**BEFORE THE PUBLIC UTILITIES COMMISSION
OF THE STATE OF CALIFORNIA**

Order Instituting Rulemaking to Oversee the
Resource Adequacy Program, Consider
Program Refinements, and Establish Annual
Local and Flexible Procurement Obligations
for the 2019 and 2020 Compliance Years

Rulemaking 17-09-020
(Filed September 28, 2017)

**CALIFORNIA INDEPENDENT SYSTEM OPERATOR CORPORATION
TRACK 3 PROPOSAL COMMENTS**

Figure 1. Summer LCA NQC Example

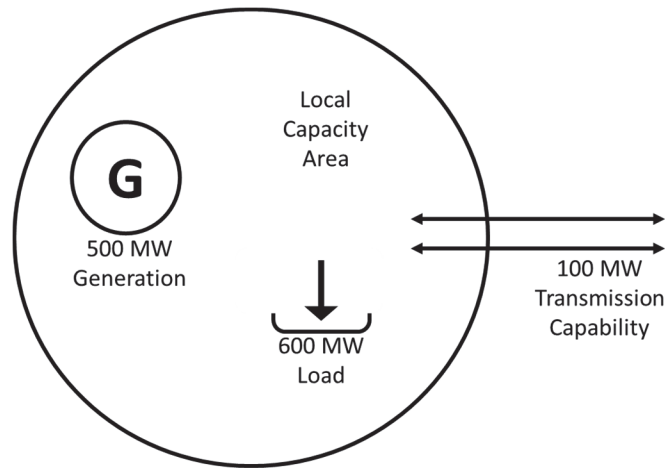
of the local area and into the system for the local area resources to be deliverable. However, the transfer capability out of the local areas during non-summer months can be less than or equal to the transfer capacity during summer months.¹³ As a result, the total energy that is deliverable from within the local area to the aggregate of load during these non-summer months can be less in the summer season. This means that resources in the local area will have their NQC reduced if the energy they produce cannot be fully exported out of the local area. Figure 1 and 2 describe this constraint below graphically as follows:

- Peak internal load conditions
- Internal generation fully deliverable to aggregate of load
- $QC_G (500MW) = NQC_G (500 MW)$

Figure 2. Non-Summer LCA NQC Example

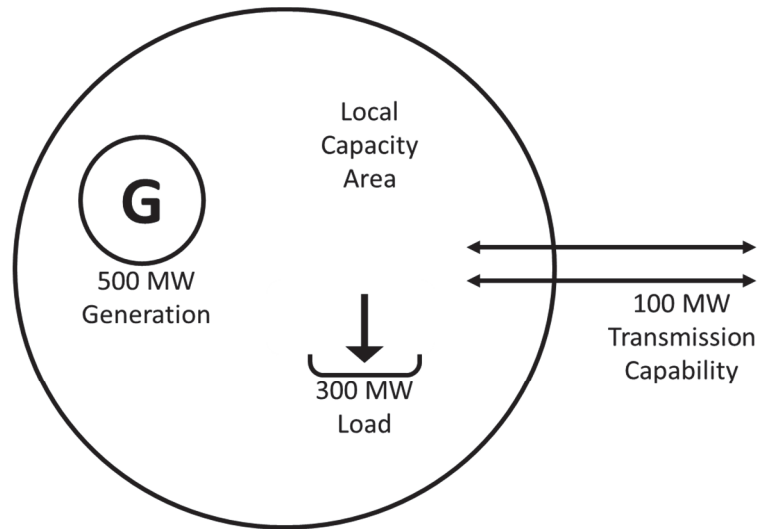
- Internal generation no longer fully deliverable to aggregate of load due to reduced internal load conditions
- $QC_G (500MW) > NQC_G (400 MW)$
